RECALL 24V005 REMEDY INSTRUCTIONS – CERTAIN Li3 MODELS ONLY

Make(s): GALLERIA Model(s): MANY, SEE BELOW Model Year(s): 2020 - 2024	Repair Code: RC-093-09-00-004514 Allotted Time: 1.50 HRS. Inspection Code: N/A Allotted Time: N/A
	Concern: In the event the battery boost wire shorts, or fails, it may shut down or damage the power steering of the vehicle. This condition may lead to a crash.	Photo(s) Required: YES, POST REMEDY Prior Authorization Required: YES Part(s) Kit Number: F100503421 Part(s) Return: N/A

2022 THROUGH 2024 MODEL YEAR - REMEDY PROCEDURE

FIGURE 1

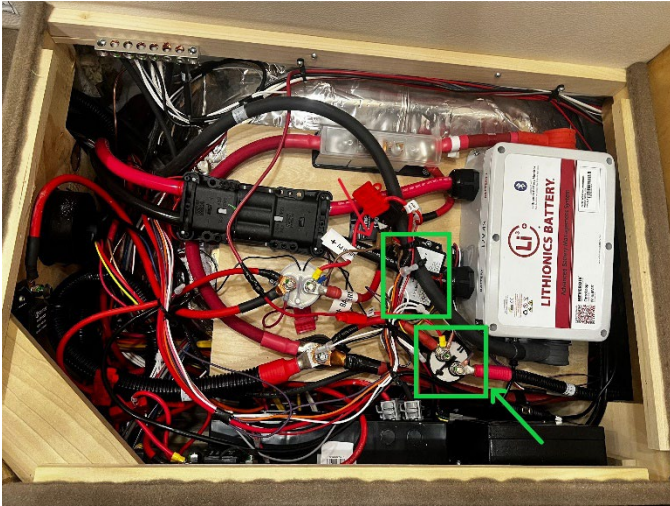
STEP 1: LOCATE AND ACCESS ACR IN MAIN ELECTRICAL COMPARTMENT (FIGURE 1);

FIGURE 2

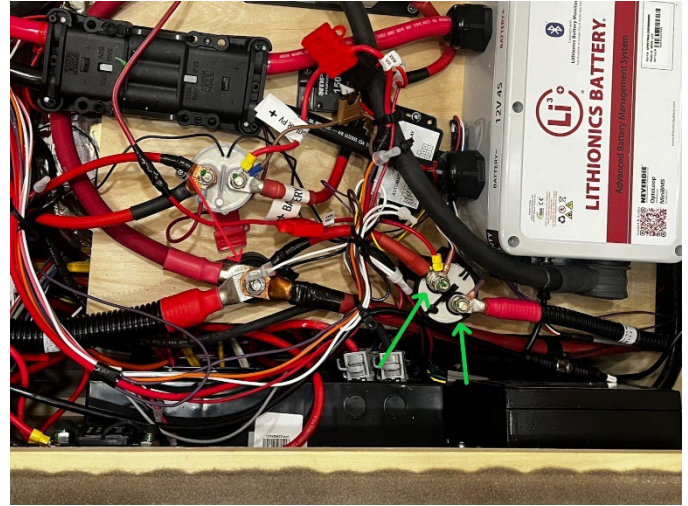
STEP 3: USE A 11/16" SOCKET AND A 9/16" SOCKET TO REMOVE THE RED 2 AWG CABLE ON POWER POST CONNECTED TO THE ACR SOLENOID (FIGURE 2);

FIGURE 3

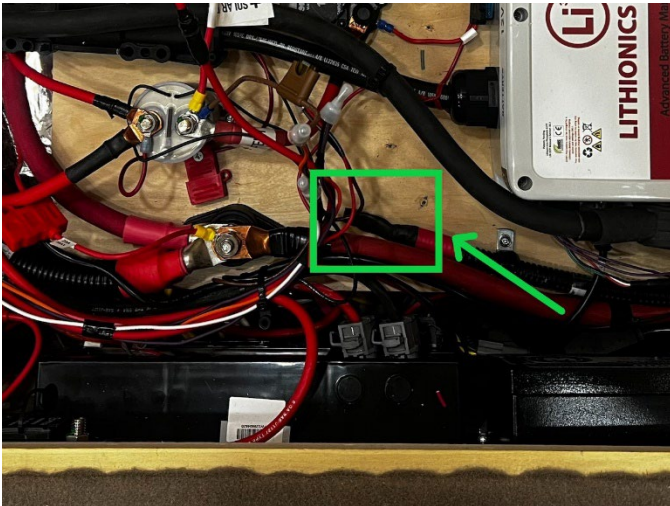
4A. APPLY HEAT SHRINK TO END OF CABLE USING HEAT GUN (FIGURE 3);

FIGURE 4

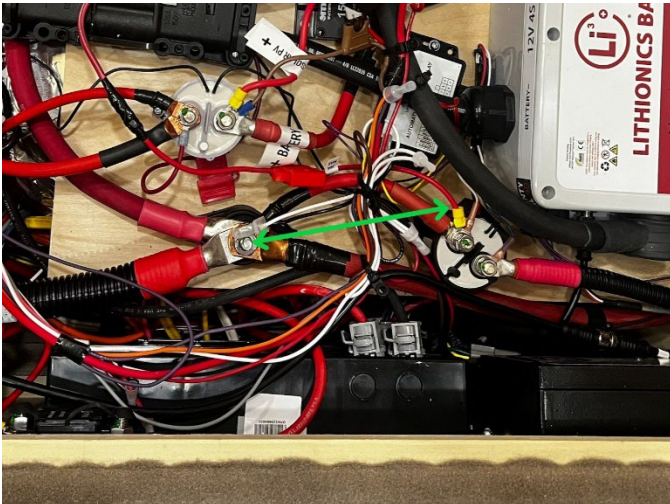
4B. LABEL CABLE WITH DO NOT USE TAG AND MOUNT TO PANEL USING P-CLAMP OR ZIP TIE (FIGURE 4);

FIGURE 5

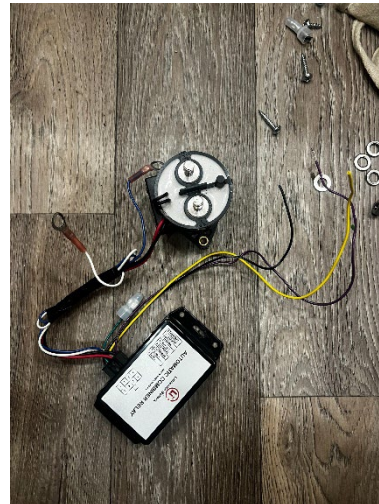
STEP 5: REMOVE IN-LINE FUSE ON SOLENOID AND RELOCATE TO POWER POST. TORQUE POWER POST TO 140 IN.LBS. (FIGURE 5);

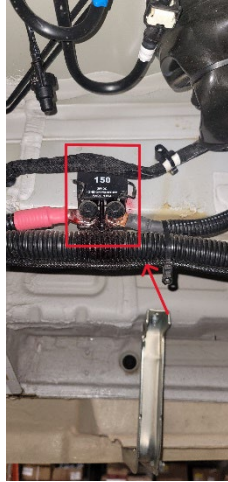
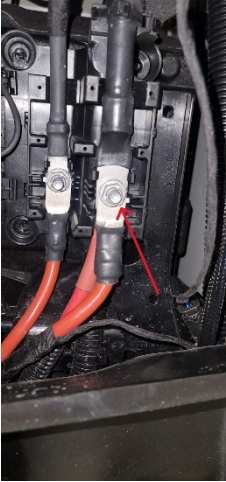
STEP 1: LOCATE AND ACCESS 150 AMP BREAKER (FRONT DRIVER SIDE - UNDER CARRIAGE OF UNIT) (FIGURE 1);

3B. TAPE CABLE INTO HARNESS (FIGURE 2);

STEP 4: REMOVE THE RED 2 AWG CABLE ON THE BATTERY SIDE OF THE 150 AMP BREAKER USING A 9/16" SOCKET (FIGURE 3);

FIGURE 2

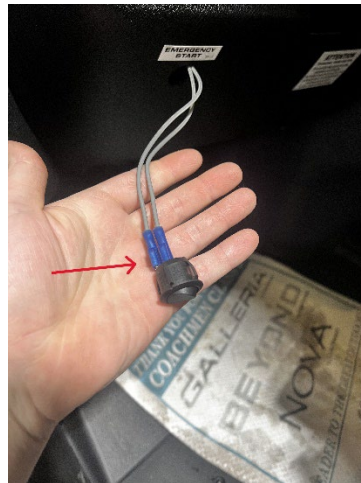
STEP 2: USING PRY TOOL, PULL SWITCH OUT FROM DASH AND DISCONNECT SWITCH FROM GREY 16 AWG WIRES (FIGURE 2);

FIGURE 3

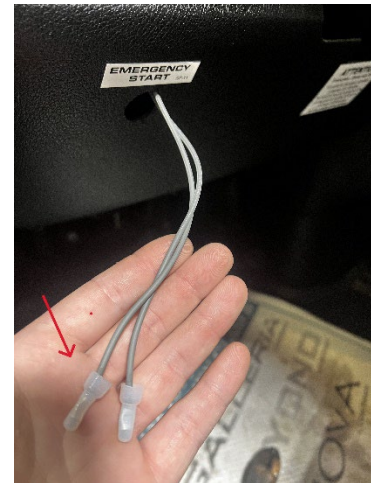
STEP 3: CAP OFF BOTH GREY 16 AWG WIRES AND TAPE TOGETHER (FIGURE 3);
